TRANS/WP.29/GRE/2002/34
17 July 2002

PROPOSAL FOR DRAFT AMENDMENTS:

TO REGULATION No. 98
(Headlamps with gas-discharge light sources)

TO REGULATION No. 112
(Headlamps emitting an asymmetrical passing beam)

OVERVIEW OF OPERATIONAL PERIODS
CONCERNING TEST FOR STABILITY OF PHOTOMETRIC PERFORMANCE

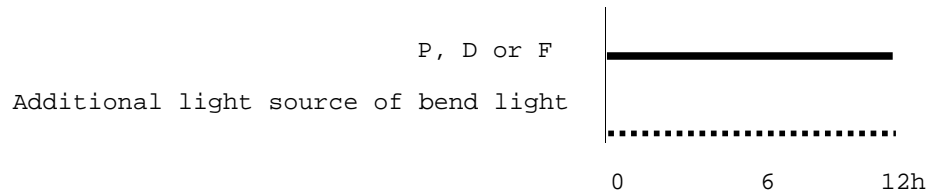
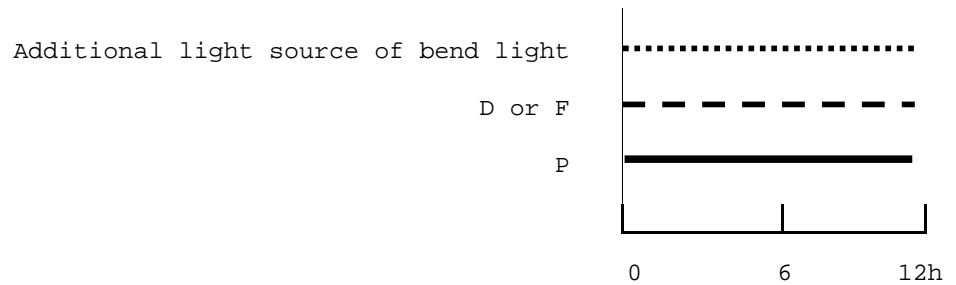
Industry requested the Working Group Photometry to clarify the situation for the test procedure on behalf "TEST FOR STABILITY OF PHOTOMETRIC PERFORMANCE" in case of bend lighting function. Because the bend lighting function is in case of an additional light source only active for a short time period, industry sees a need to modify the test procedure (see overview of operational periods in annex).

- "(d) In the case of a passing beam designed to provide bend lighting with the addition of a light source, this light source shall be switched on for 1 minute, and switched off for 9 minutes during the activation of the passing beam only."
